TE Connectivity

Product Change Notification: E-20-015569

Modification PT relay base

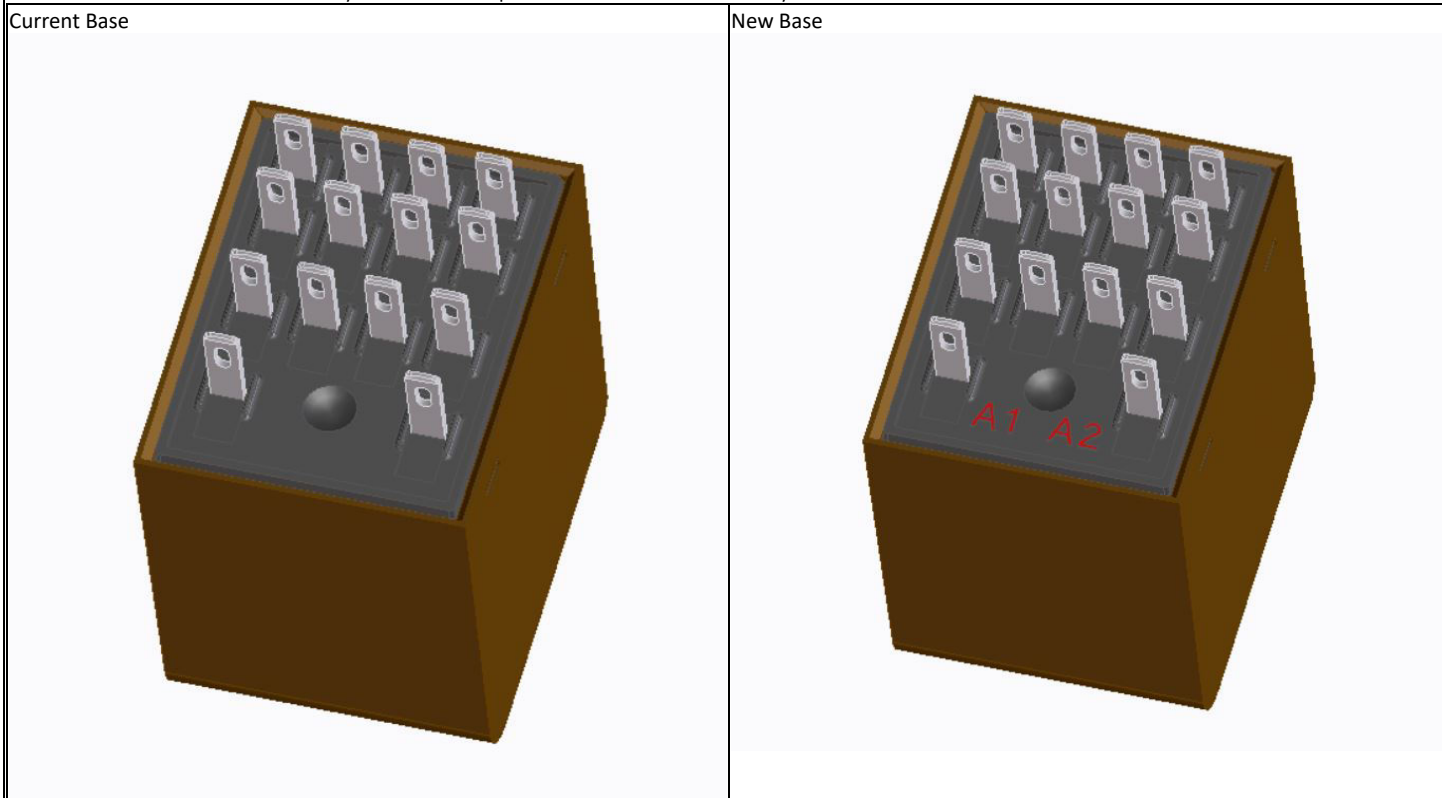
At the bottom of the relay base coil pin indicators were added, see red marked area. These indicators were added in the mold of the base and will protrude a maximum of 0.2mm. The modifications do not have any influence of the specification or behavior of the relay.

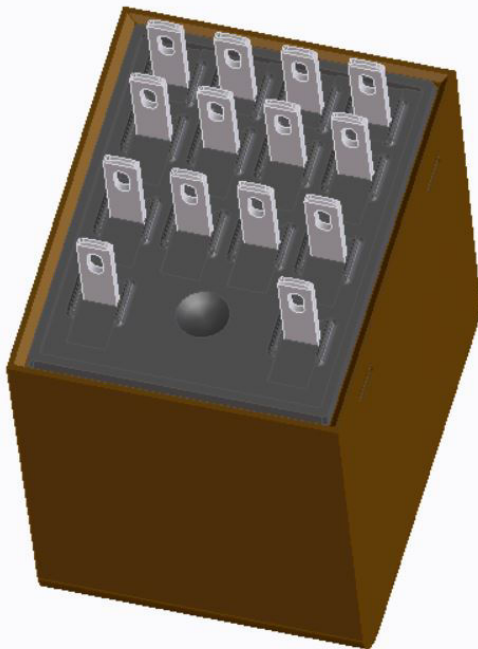
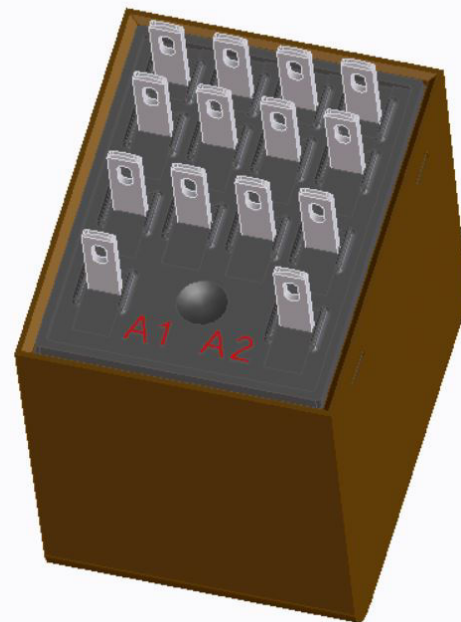
At the bottom of the relay base coil pin indicators were added, see red marked area. These indicators were added in the mold of the base and will protrude a maximum of 0.2mm. The modifications do not have any influence of the specification or behavior of the relay.
